Re: Blue Vista Subdivision, Town of The Blue Mountains
Revised Draft Plan

Re: Blue Vista Subdivision, Town of The Blue Mountains
Response to Comment for Draft Plan Application

We are in receipt of Town of The Blue Mountains Planning Review Committee Comments for the Blue Vista Application for Zoning By-Law Amendment and Draft Plan of Subdivision for Part Lot 17, Concession 1 in the Town of The Blue Mountains, Town file #P2737, dated June 11, 2019.

Figure 1: Development Traffic Volumes (180 units)

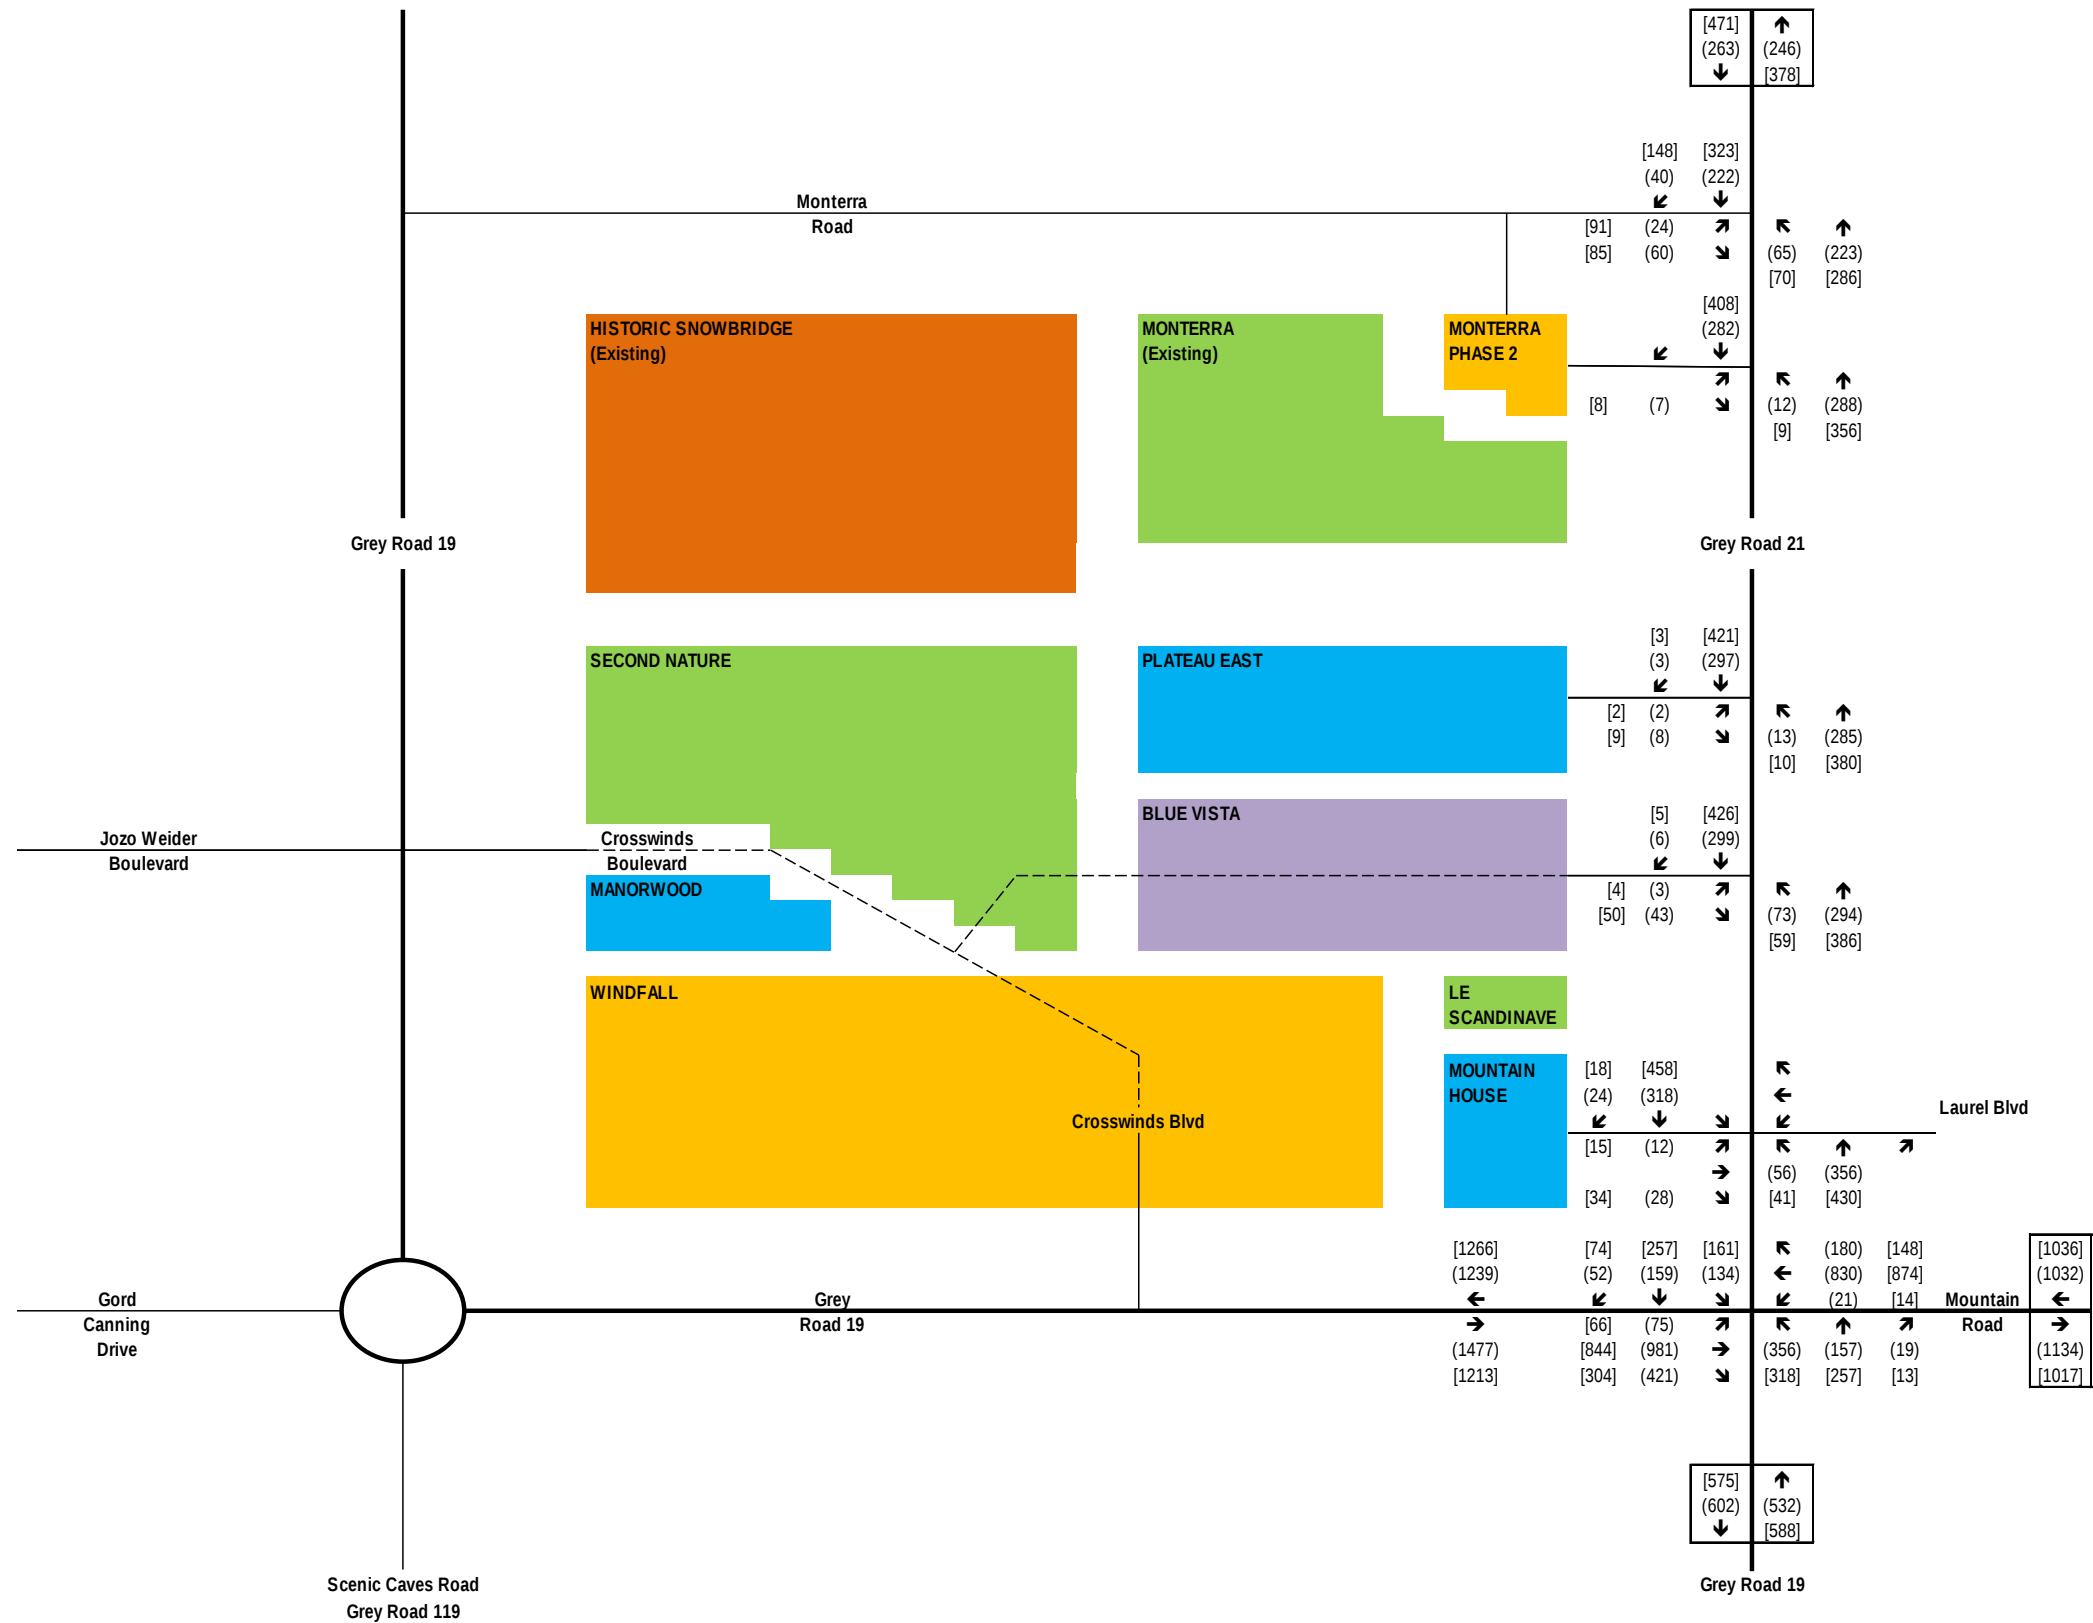
- c. The Traffic Impact Study only contemplates 133 units where up to 180 units can be considered. Report to be revised to consider 180 units.
- d. Road Intersection calculations are also required on westerly road connections: Grey Road 19 and Crosswinds Blvd; and Crosswinds Blvd and Street 'C' (Second Nature).

- c. An addendum letter has been prepared under separate cover to consider the traffic impacts of increasing the density to 180 units. As documented in the addendum letter, there are no changes to the findings of the original TIS when considering the increase 180 units, with the exception of the recommended northbound left turn lane on Grey Road 21 at the site access, the timing for which is accelerated to the 2025 horizon.

The resulting site generated traffic volumes (for 180 units) are illustrated in Figure 1, following the same distribution patterns set out in the previous traffic impact study.

Figure 3A: MTO Left Turn Warrant - GR21 & Site Access

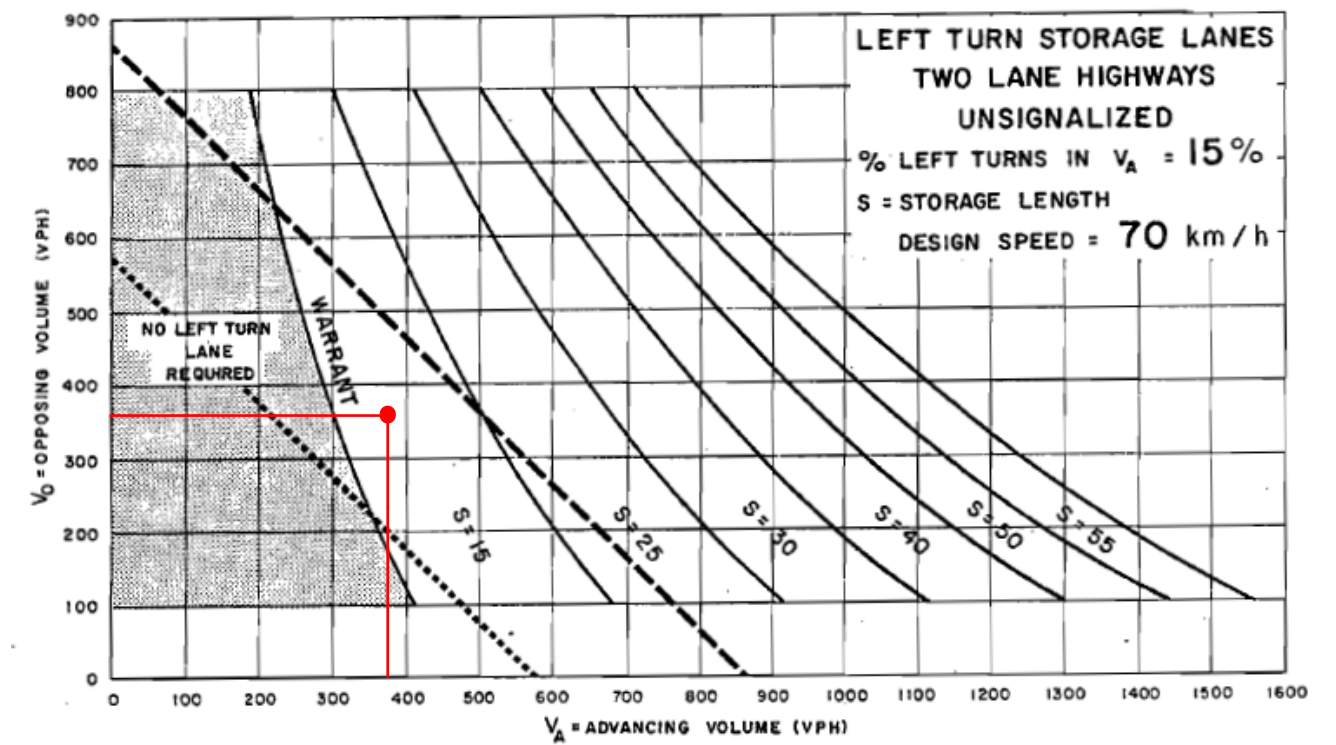
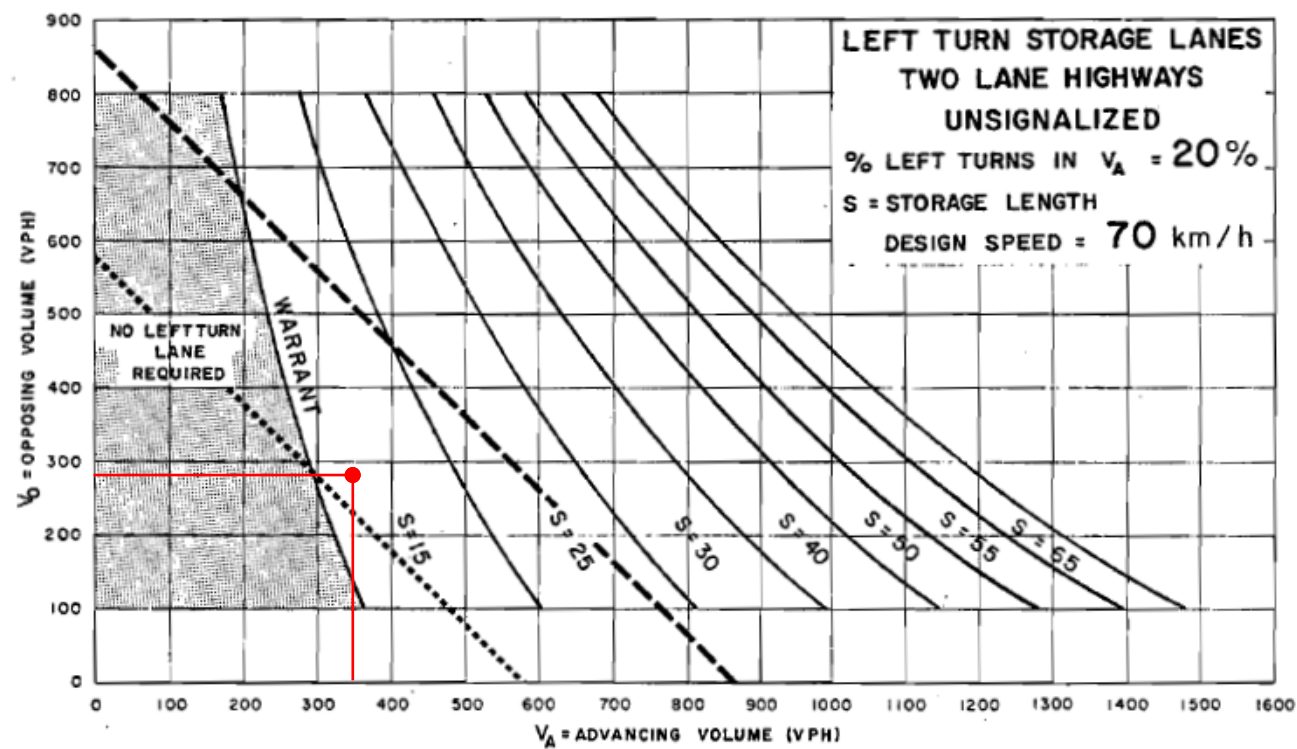
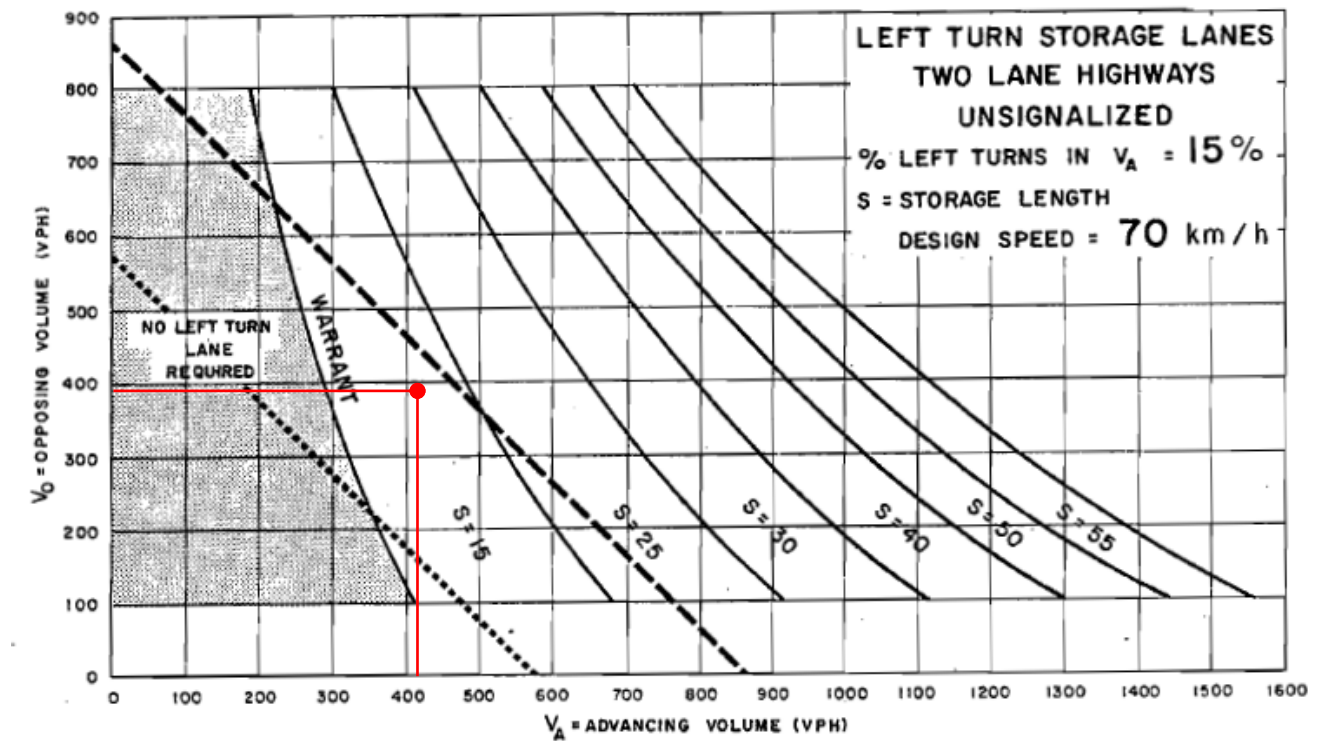
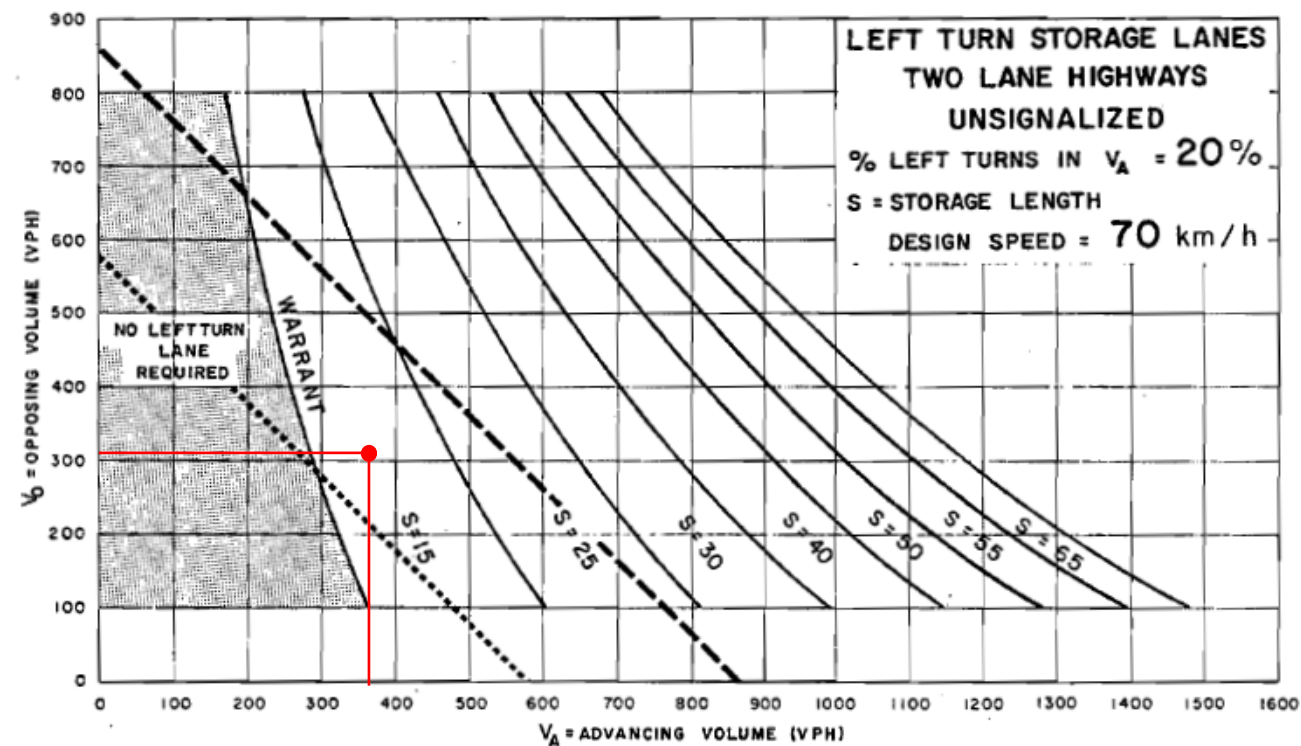
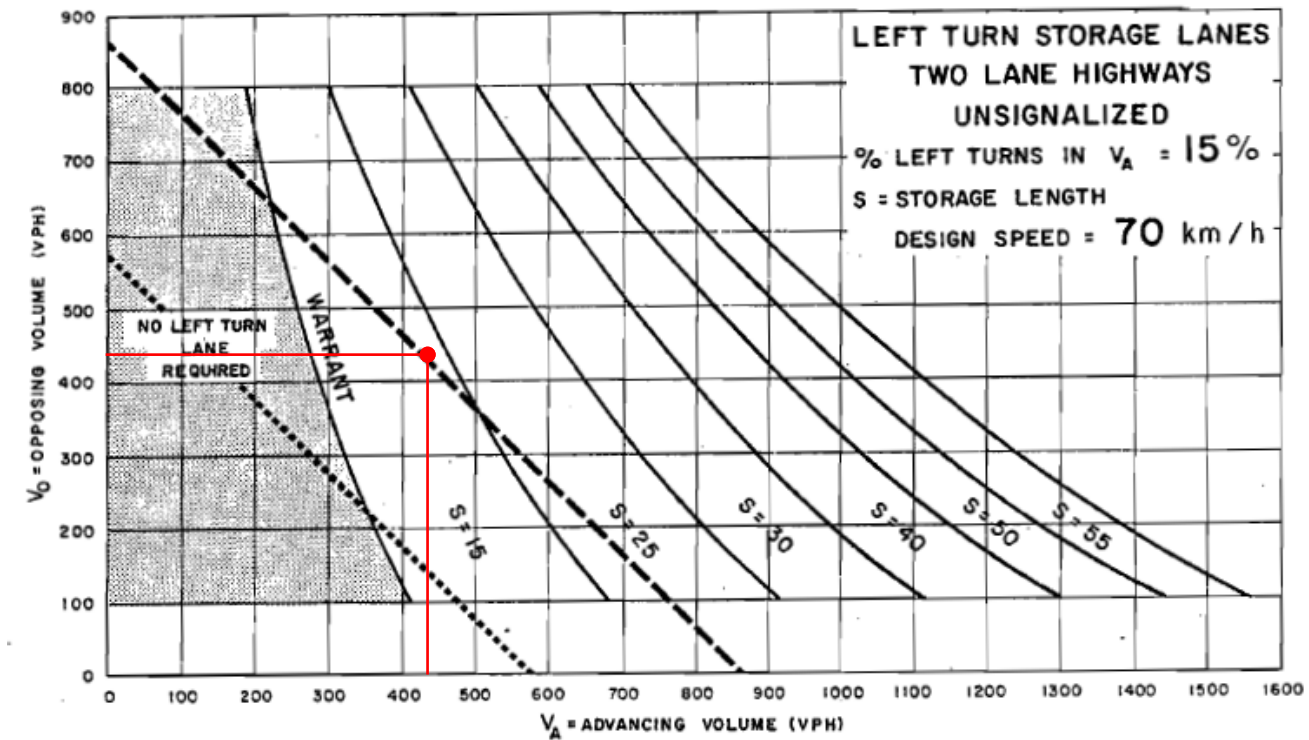
- h. Please comment on how accurate past modeling has been in predicting an increase to traffic modeling around the village.
- i. What is the trigger for installation of the left turn lane on Grey Road 21.

- i. The need for and timing of the northbound left turn lane at the Blue Vista access is somewhat dependent on the future traffic volumes on GR21. If volumes are lower than expected, the need for a left turn lane may be delayed; conversely, if the volumes are higher than expected, the need may be accelerated. The initial TIS (which considered 133 units) identified the need for a left turn lane by the 2030 horizon year (i.e. 5-years after full build-out); whereas the addendum letter (which considered 180 units) identified the need in 2025. In this respect, full build-out (or a unit count between 134 and 180) triggers the need for a left turn lane.

northbound left turn lane with 15 metres of storage is warranted under the 2025 total conditions. It is noted that the same is warranted under 2030 and 2035 and total conditions. The completed warrants are provided in Figure 3.
